## **Board of Architectural Review (BAR) Certificate of Appropriateness**

| Information on Subject Property  Physical Street Address:  250 WEST MAIN STREET  City Tax Map/Parcel: 28 - 84300   | Name of Historic District or Property:  DOWNTOWN  Do you intend to apply for Federal or State Tax  Credits for this project?  |

Re: Lewis & Clark Condominiums

Intersection of South, Water and ridge Streets

(1) CORNER BHOWING PREVIOUSLY REPLACED BRICK

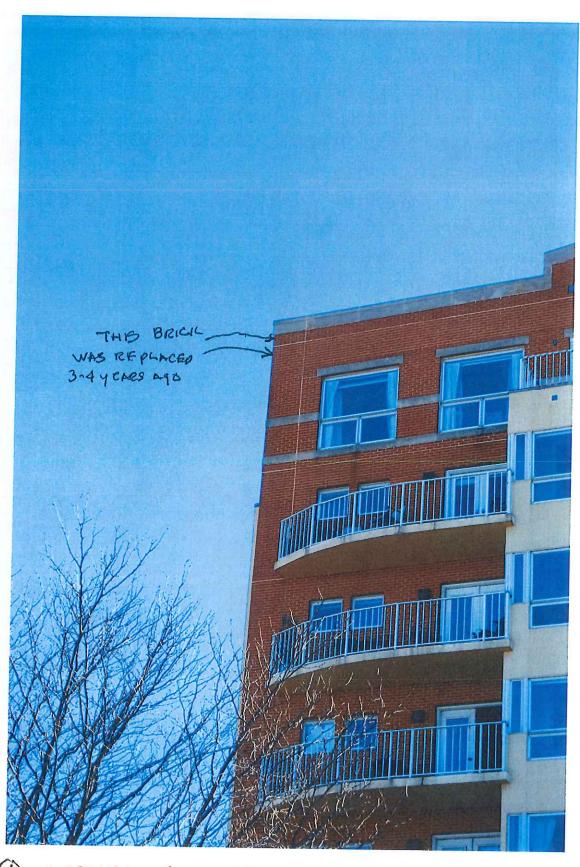
- Lowering the invert of the copper scuppers The lower lip of the existing scuppers is about four inches higher than the threshold of the doors to the roof terraces. Water flows into the building before reaching the lip of the scupper. We are proposing to elongate the scupper for positive drainage.
- Repair of the brick at the parapet corners. Irreversible expansion of brick from ineffective expansion joints has pushed the parapet masonry about an inch beyond the plane of the wall. A few years ago we made similar repairs to the upper level parapets. To accomplish this repair we will recut the expansion joints and replaced the brick on the corners.

Unfortunately, the affected brick was made at the now defunct Somerset Webster plant> It is also a gas fired product. We have located two similar products: one made by Belden (form Ohio) and the other from Palmetto Brick (in South Carolina). On the upper level repairs we used the Belden material and propose the same for the lower level. The earlier installation should serve as a reliable sample for the anticipated work.
